**Dwayne Bourgeois**

North Lafourche Conservation, Levee and Drainage District

*The National Flood Insurance Program: The Need for Long-Term reauthorization and Reform*

# **Appeal of Proposed Flood Elevation Determinations (Preliminary DFIRMS)**

# Attachment A

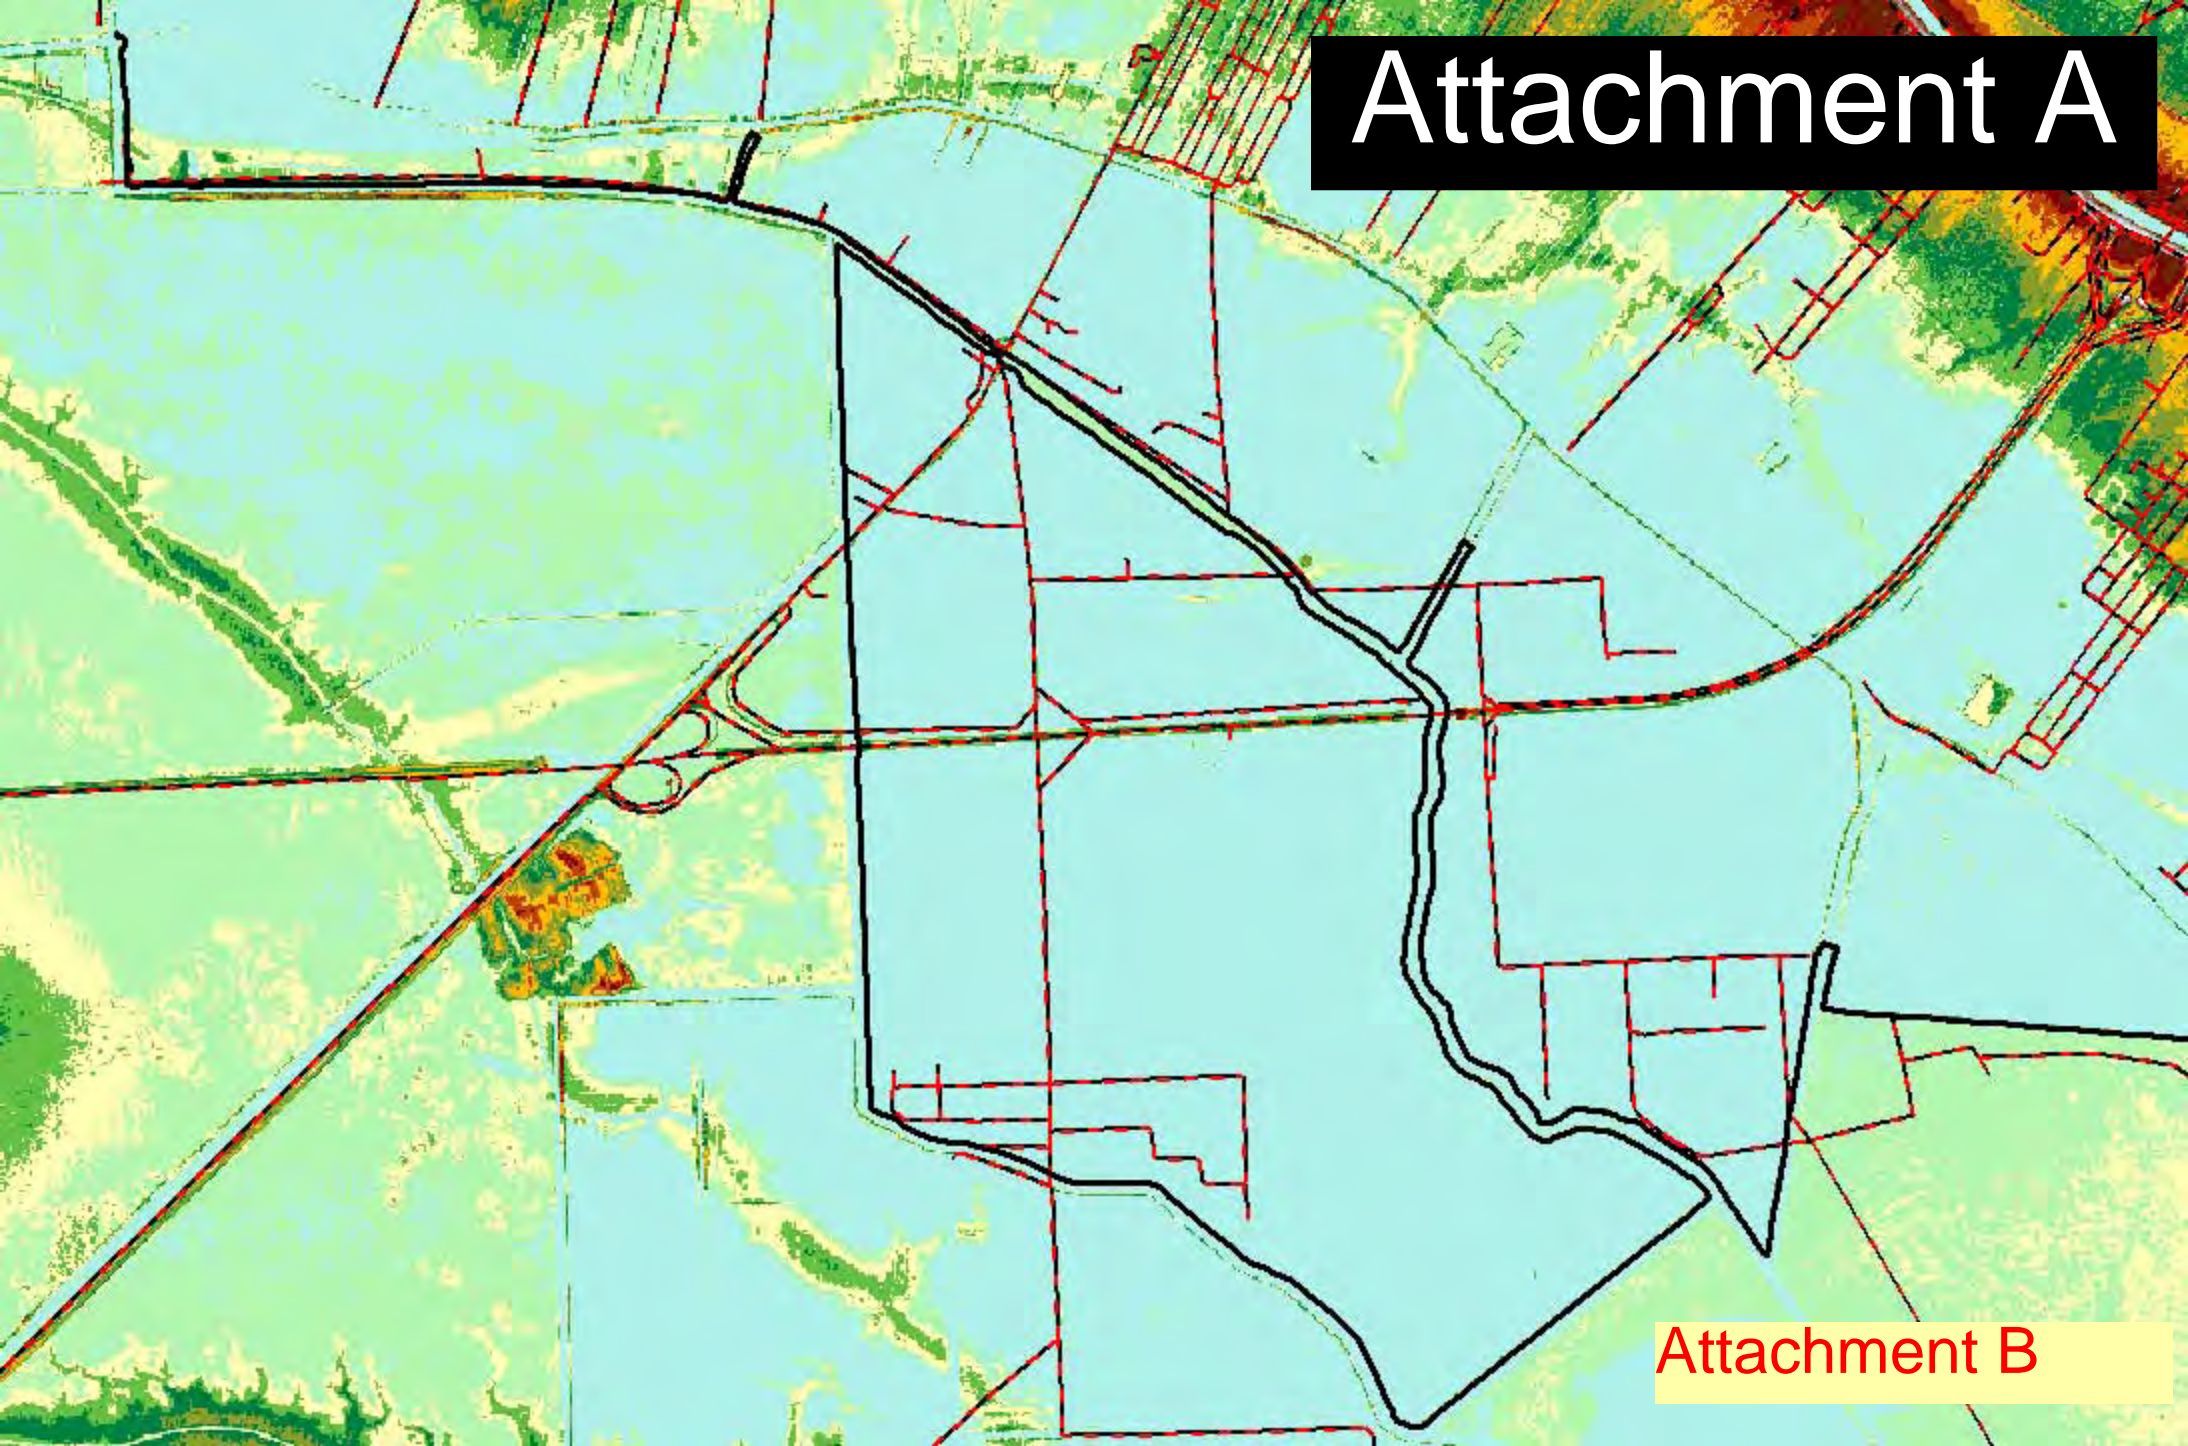
One example of this obviously inaccurate DFIRM is found in Attachment A. This attachment is a collage of three DFIRM Panels (Map Numbers 22057C0350E, 22057C0355E and 22057C0365E) so that a real world example of erroneous mapping can be demonstrated. This attachment has been highlighted to include some real world features that appear to have been missed in the mapping process. Highlighted in red is the location of an 8.2 mile ring levee system originally constructed by the USDA and currently maintained by the Lafourche Parish

Government and the NLLD. Presently, the elevation at the centerline of this levee system is approximately 5.5 feet or greater throughout its length. This sub drainage district has a series of major internal drainage channels highlighted in blue leading all areas of the basin to its two pump stations as indicated. LIDAR mapping (See Attachment B) for the same area shows that the ground elevation in the area is nearly at the same elevation throughout the district.

Given these real world conditions, the wave run-up which centers and peaks on transect 5 just outside of the highlighted ring levee system indicates that the ring levee system was not at all considered in the wave analysis. Consequently, this small drainage sub district includes 7 different base flood elevation requirements. They include a VE8, AE7, AE6, AE5, AE4, AE3 and an X zone.

The lines separating these 7 base flood elevation zones have no correlation to any features in the real world. Pretty much anywhere in this area you could have two people, standing 500 yards or less apart from each other, looking at each other eye to eye, and there will be 2-3 different base flood elevation requirements between them. And the land between them is flat from one person to the other. This simply can't be.

Further, this obviously erroneous mapping process must have an effect on the adjacent ring levee systems, similar in makeup to the highlighted one, to the east and southwest of the highlighted system. But what effect might that be if the noncertified levees of all of these systems were simply ignored in the wave analysis? As a final demonstration of the nonsensical along this same transect, just southeast of the highlighted system is Lake Fields. Lake Fields is a significant, completely open body of water. However, the result of this mapping process is to reflect an AE7 Zone in the northern and southern parts of the lake with an AE6 zone in the center of the lake. No VE zones in the lake, just on the shore.

What we propose as an alternative is not really an alternative process. For the most part, we can agree with the process described in the CFR with the additional Guidance except for indiscriminately removing noncertified levees from the wave analysis. We propose that FEMA should complete the modeling portion of their FIS with all certified and uncertified man made levees included in all phases of the modeling and mapping process so that these features can be fully accounted for within the FIS at all locations. (i.e. Let the SCIENCE run its course.)

After the output of this modeling and mapping is complete, FEMA could then consider how to address the risk to property within those levee systems that are not certified. As such, a compromised elevation might be required even where the modeling shows no overtopping or limited overtopping and filling of the basin. The zones within such a basin could then be drawn along logical geographic features within the basin proportionate to the perceived threat. This will result in maps that the local residents and businesses can believe in.
